Cap Fastener Upgrade

***Field Service Bulletin
802240 - Revision 1***

IM-224

Revision 1 August, 1995

Figure 3 Capacitor Fastener Upgrade

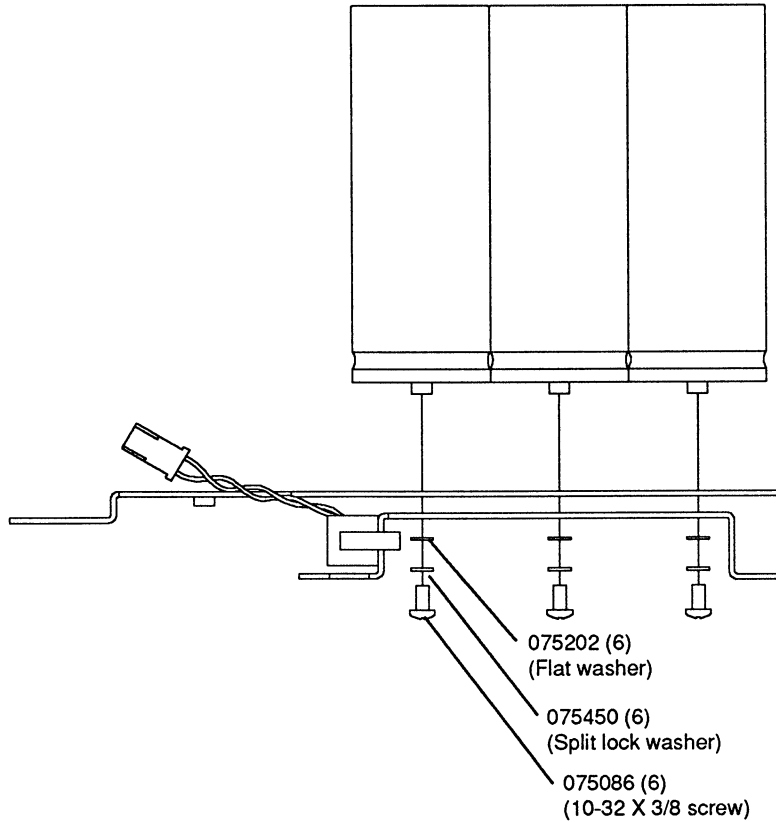
This field service bulletin will enable a qualified electronic technician to modify the CH100 assembly by removing twelve internal star washers that help to support the large blue capacitors (009905) on the chopper assembly, and replacing them with six flat washers and six split lock washers.

This upgrade is an improvement to earlier capacitor fastening designs for the CH100 chopper. Under certain conditions, the internal star washers on earlier units can cause arcing and increase electrical resistance which could result in failure of the large capacitors.

7. Remove capacitors from bus bars and discard capacitor fastener hardware (six (6) screws and twelve (12) internal lock washers per chopper).

8. Install new hardware from kit as shown in Figure 3. **Be certain that capacitor polarity is correct when fastening to bus bars!** See Figure 4.
